# **Two Wells Ambulance Station**

## Stormwater Management Plan

<b>To</b>	Wayne Schiller - GGA		
<b>From</b>	Tonkin	<b>Date</b>	17 July 2025
<b>Job Number</b>	241697		
<b>Subject</b>	Council Concerns Regarding Stormwater Management for New Two Wells Ambulance Station

Adelaide Plains Council ('Council') has raised concerns regarding stormwater management for the new Two Wells Ambulance Station. The concerns quote the stormwater management plan ('SMP'), however the concerns that pertain to stormwater do not quote the South Australian Planning and Development Code.

## **Appendix C – Drainage strategy**

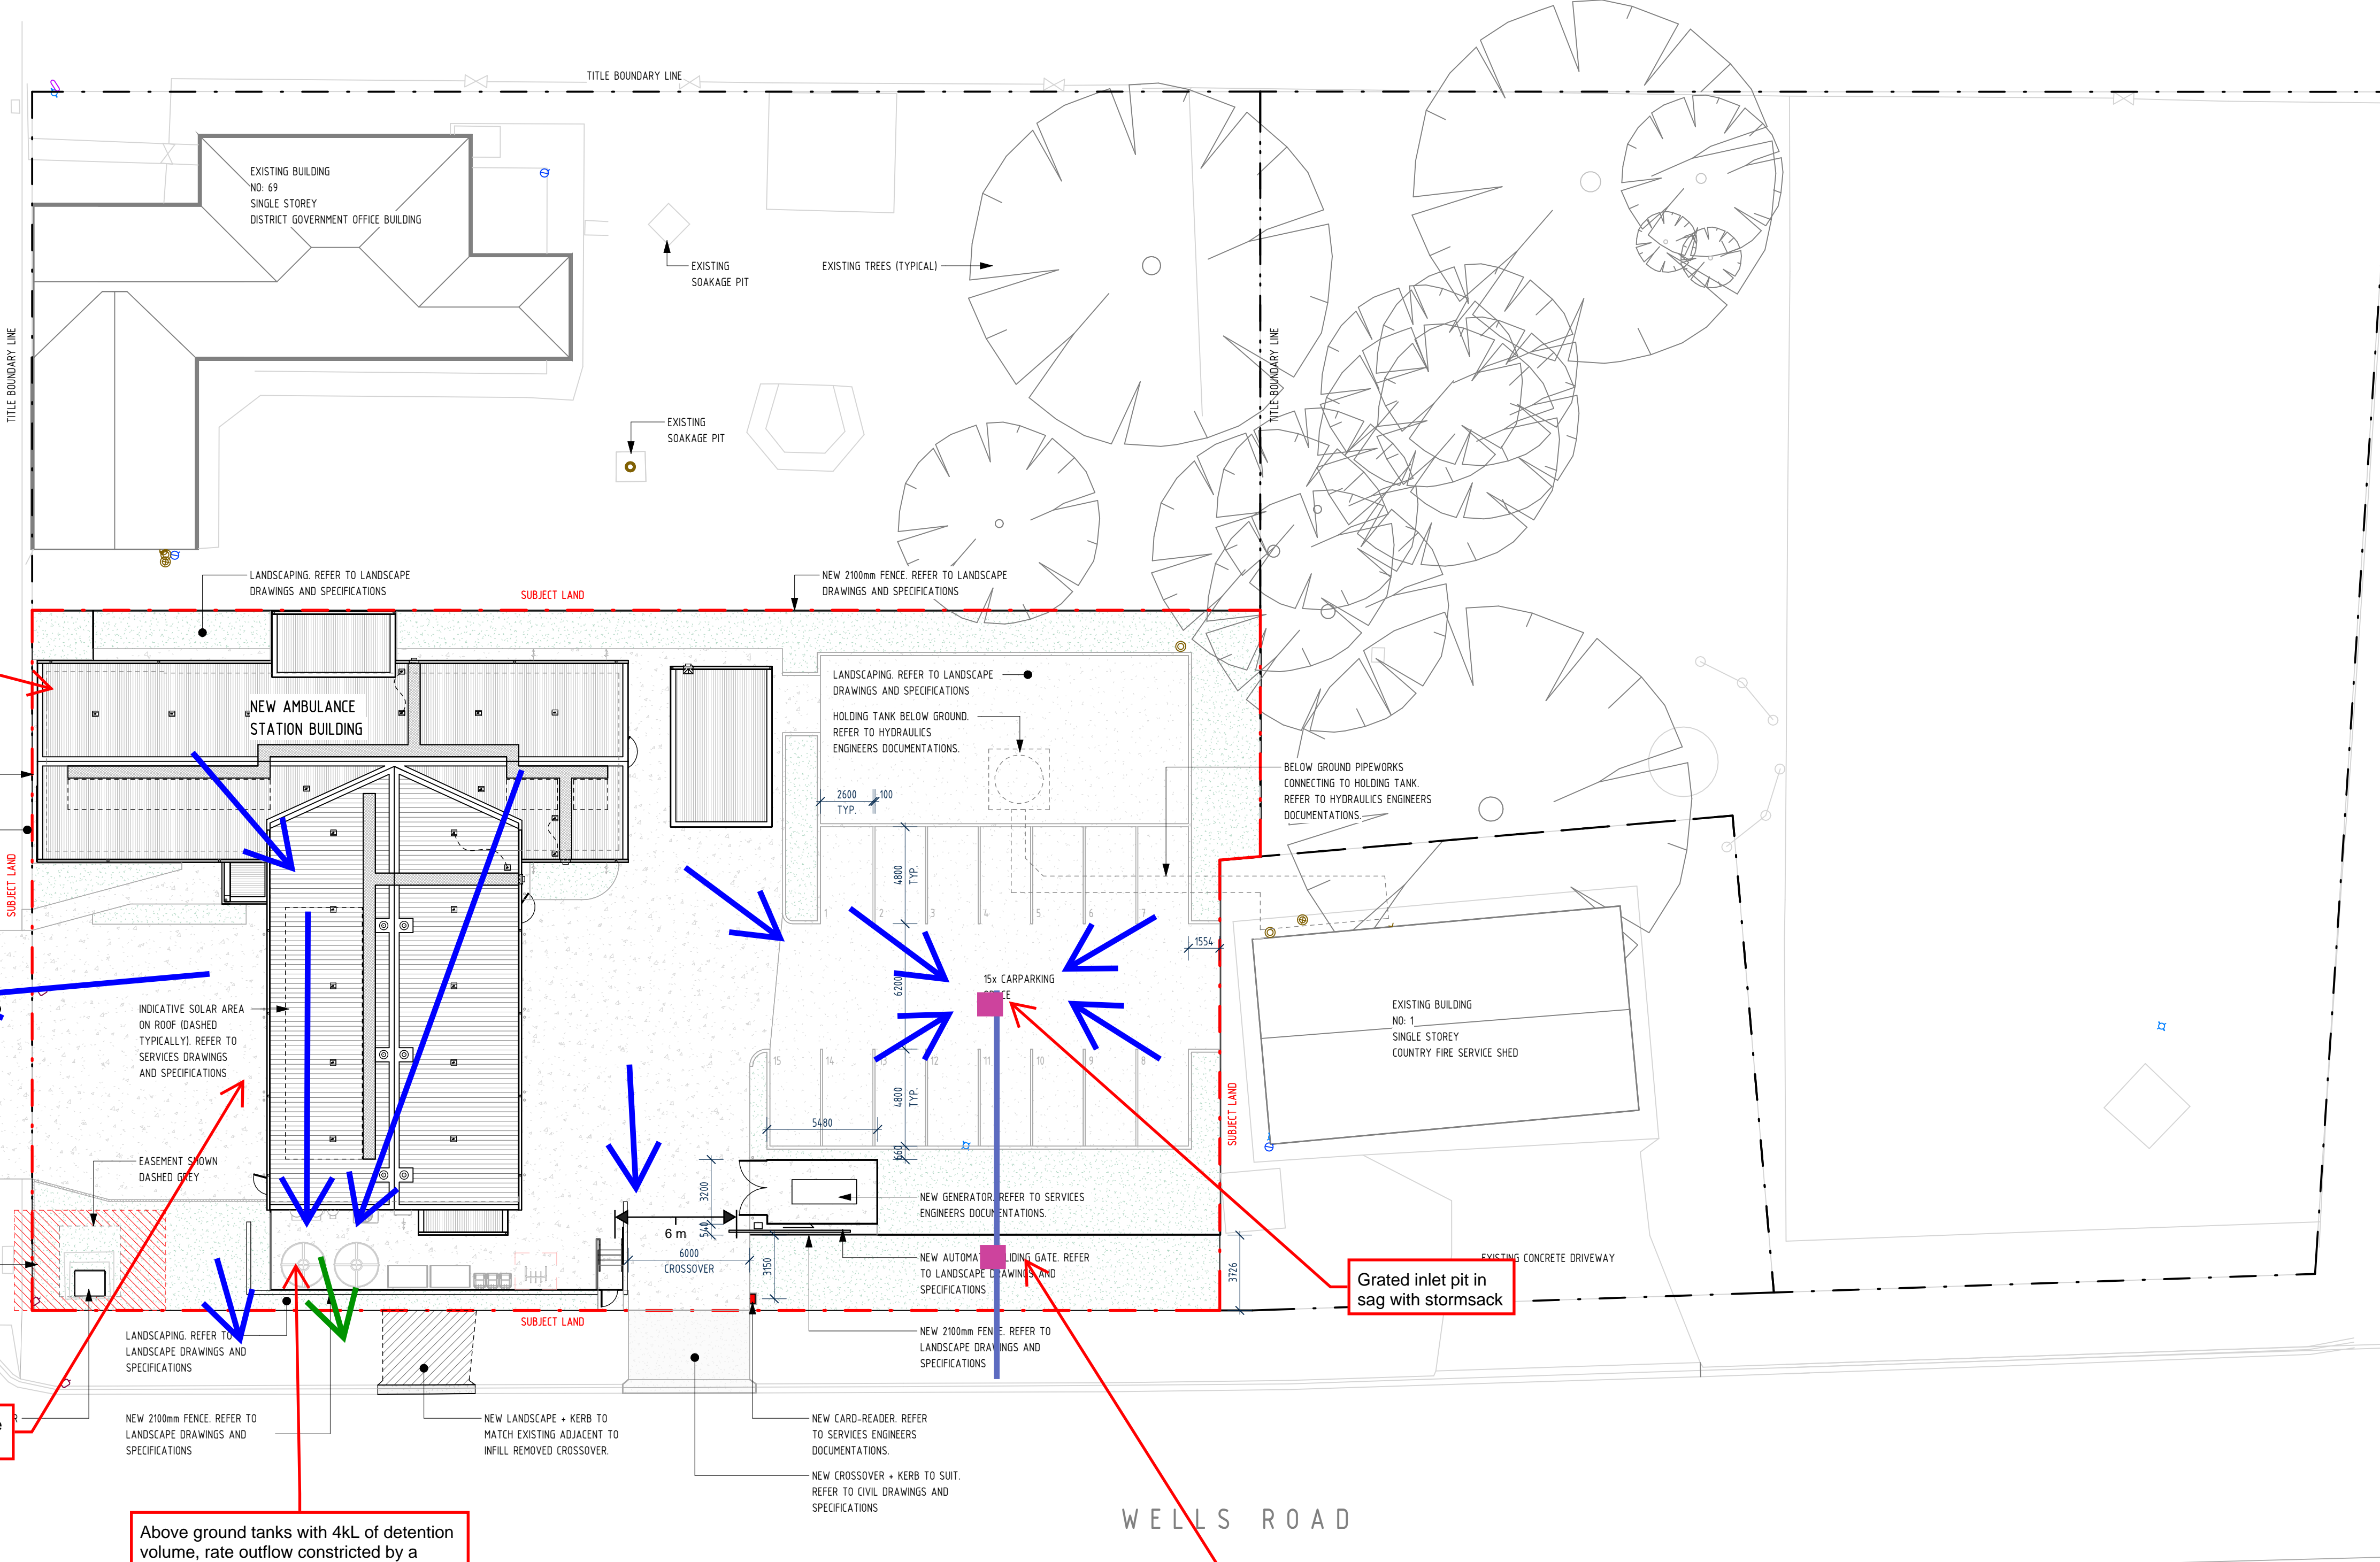
*'Comment: The current design does not reflect this approach. Instead, stormwater is collected from the proposed car park via a spoon drain and grated inlet pit and discharged directly into Wells Road — this is not supported by Council.'*

*'Stormwater from the existing office building must also be managed onsite and must not cross property boundaries. An alternative solution is required.*

*Stormwater systems must be designed and constructed independently for each land parcel. Shared systems spanning property boundaries are not supported.*

*Council does not support stormwater systems that cross allotment boundaries without formal legal agreements. The proposal must demonstrate that stormwater can be lawfully contained and discharged within the development site to ensure long-term functionality and compliance.'*

The design has evolved since the SMP was written and opportunities for infiltration are now more limited. Rainwater tanks that include retention-reuse volume in addition to the minimum retention volume mandate in the SMP .

The SMP recommends oversizing of rainwater tanks to reduce runoff volume. The underground drainage from the new SAAS carpark will also feature perforations and granular backfill in the trench to encourage infiltration and reduce runoff to Wells Road.

Council has been supplied with a concept markup plan on rerouting the existing downpipes to Old Port Wakefield Road via kerb outlets that front council chambers' allotment.

Council's comment of *'Stormwater must be managed onsite and must not discharge directly into the street'* is a broad statement and not referencing to any policy requirements. The design is being updated to include a trash basket at the parking lot to treat gross pollutants, sediment and nutrients. To effectively manage treatment of any hydrocarbons, typically a gross pollutant trap would be introduced into the design. However, given the lack of stormwater infrastructure to connect into and site constraints, introducing a pollutant trap into the carpark design and layout will introduce design and construction complexities as well as result in additional maintenance for the client. A practical approach originally adopted was for runoff to discharge across a vegetated buffer strip to be partially infiltrated. The current stormwater design does not allow for runoff to be discharged across a vegetated buffer strip. The latest designs feature perforations in the carpark drainage pit so that there will be opportunities for runoff to infiltrate into the surrounding soils before discharging to Wells Road, which will be similar to the original stormwater management plan.
